Project Name
Dannat House, Templewood Avenue

Title
Proposed North East Elevation

Drawing No.
1803-PL-18

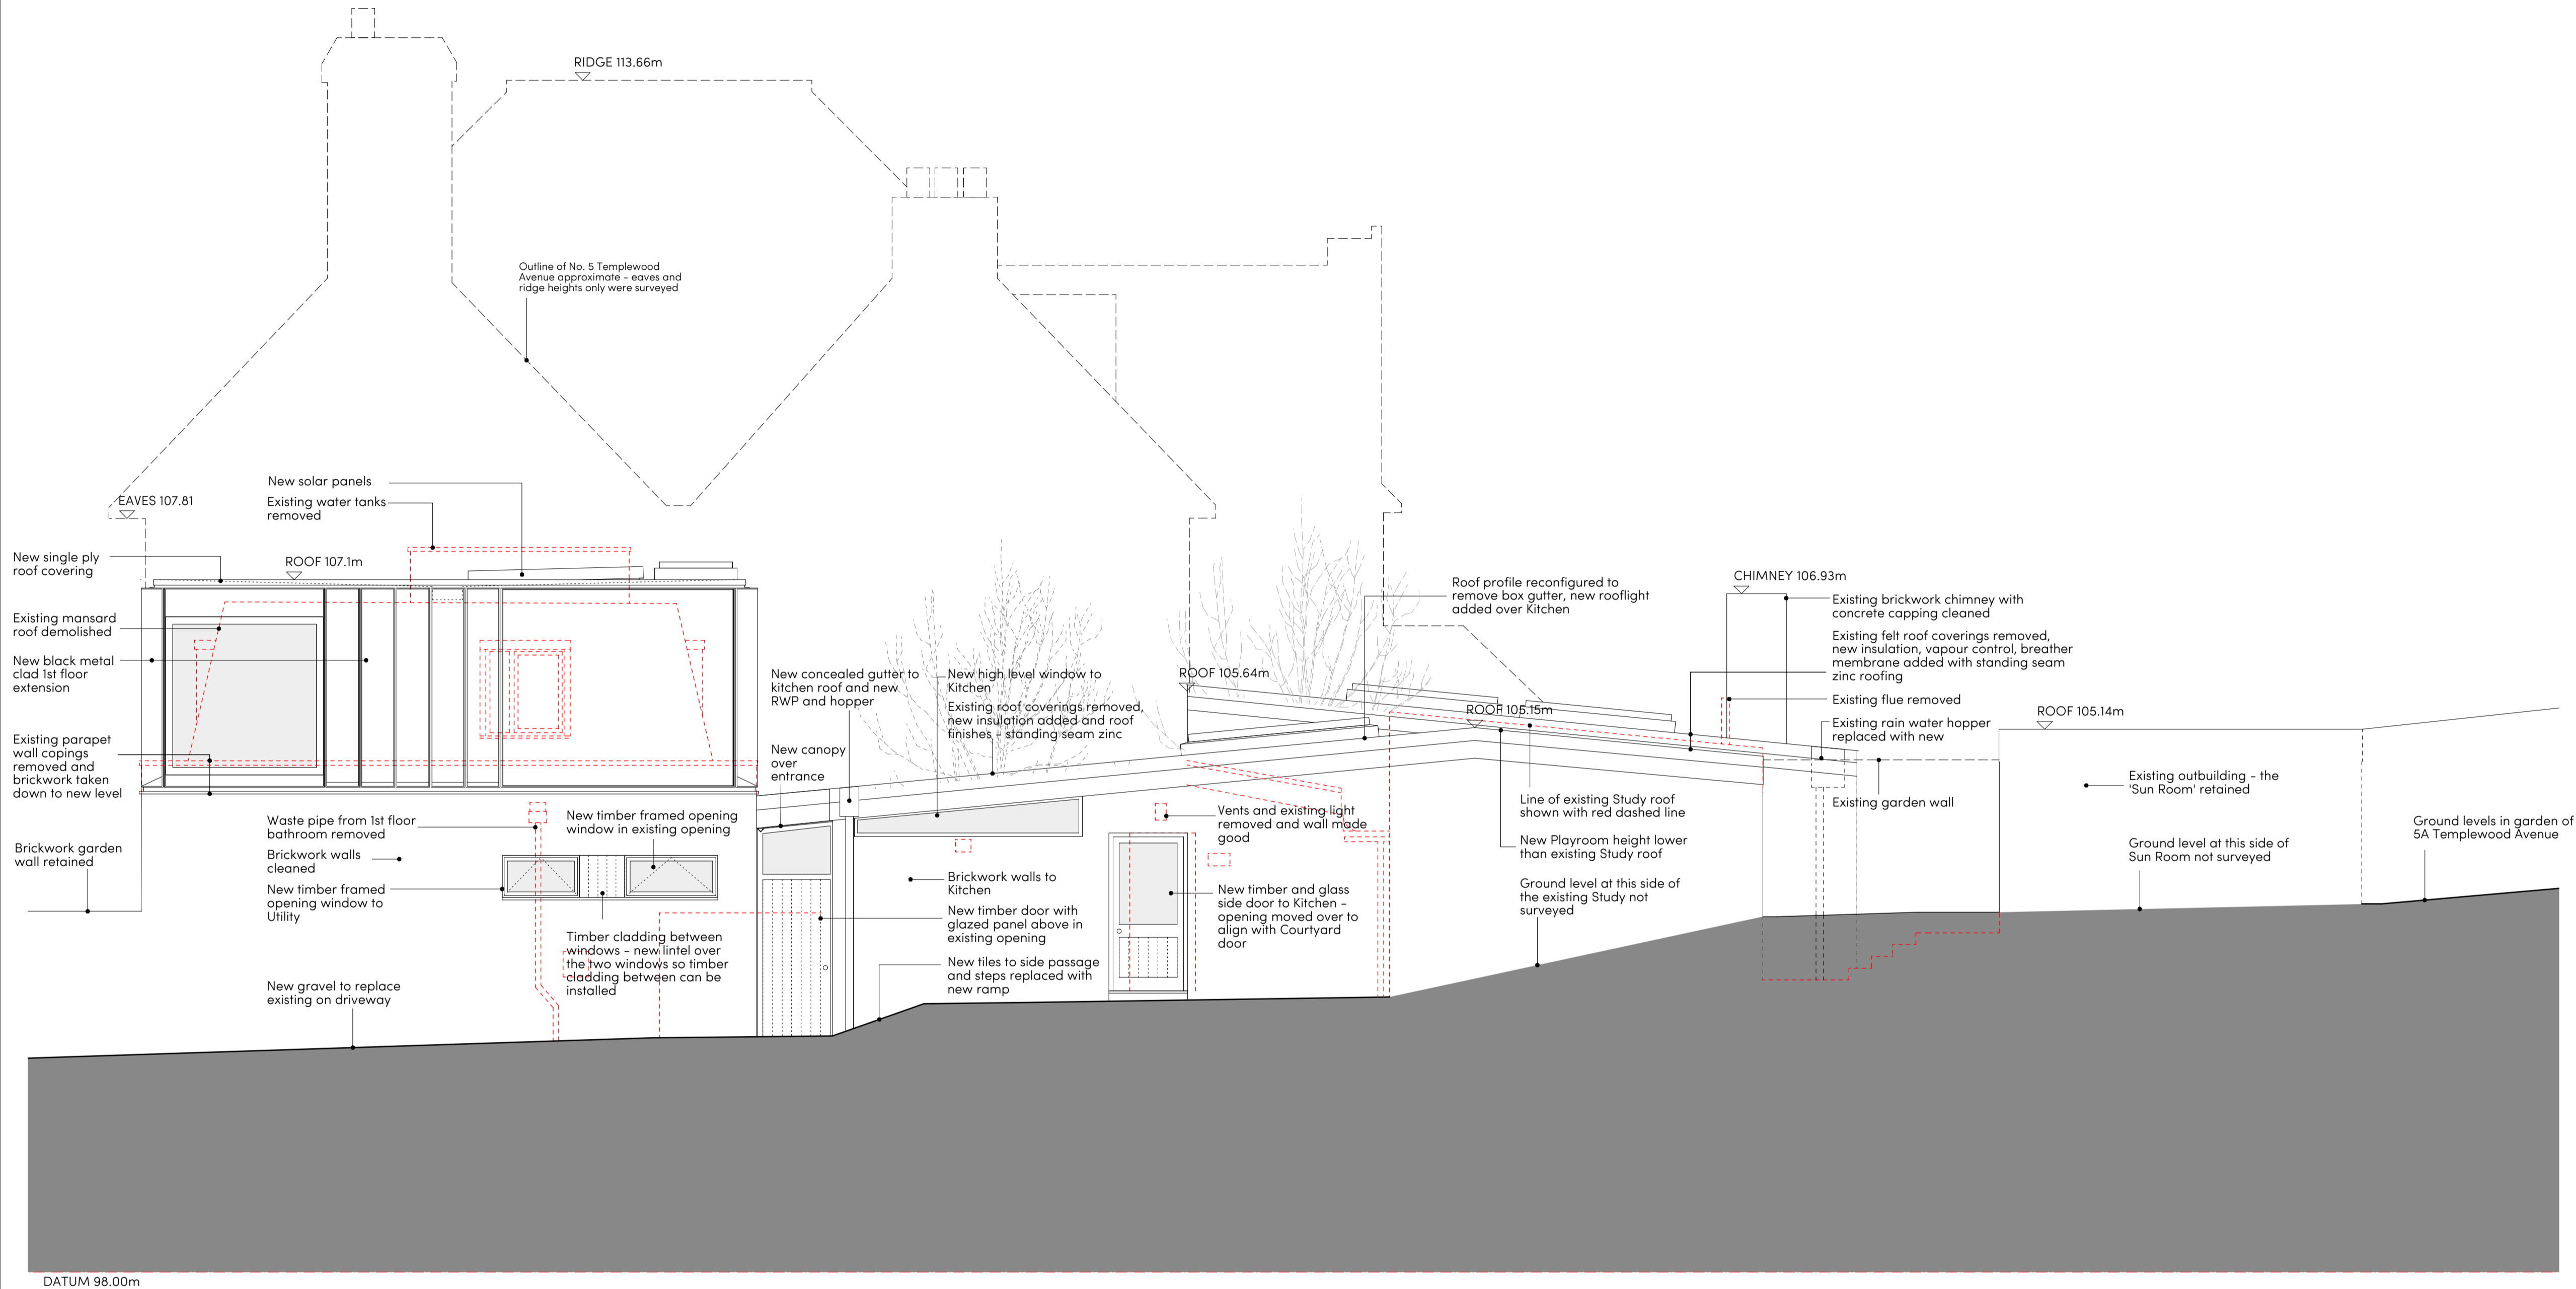
A	5/2/20	Existing Kitchen door moved over to align with Courtyard door - door not made taller as proposed previously. Adjacent high level window made taller so sill aligns with top of door opening.
---	--------	--
